Alameda–North Bay Farm Island Pipeline Crossings Project

Final Environmental Impact Report

NOVEMBER 2016

This Response to Comments document has been prepared to accompany the Draft Environmental Impact Report (Draft EIR) for the East Bay Municipal Utility District's (EBMUD) Alameda-North Bay Farm Island Pipeline Crossings Project (proposed project). The Draft EIR evaluated the potential impacts of the proposed project and recommended mitigation measures to reduce significant and potentially significant impacts. This document responds to comments on and makes revisions to the Draft EIR, as necessary. The California Environmental Quality Act (CEQA) and its implementing regulations (the "CEQA Guidelines") require a lead agency to prepare and certify a Final EIR before it may approve a project for which a Draft EIR has been prepared. Together with the Draft EIR, this Response to Comments document constitutes the Final EIR for the proposed project.

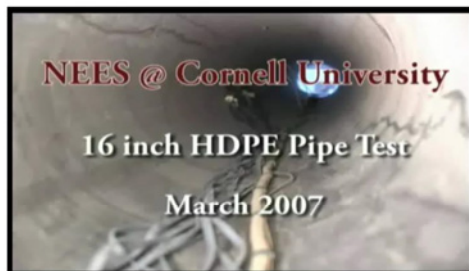
HDPE pipe has proven to withstand large seismic events. How many of you have seen coils of yellow pipe on PG&E trucks?

- That pipe is joined by what is commonly known as hot plate welding
- Since the joints are fused & it all becomes one piece, there is no leakage
- 96% of all natural gas distribution lines in the US and worldwide are Polyethylene

Regarding HDPE's survivability through an extreme seismic event **there were NO Polyethylene pipeline failures** in the:

- 1989 Loma Prieta earthquake
- 1995 Kobe earthquake
- 2011 Christ Church earthquake
- 2014 Northridge earthquake
- 2015 Chile earthquake

See Master Response 1.
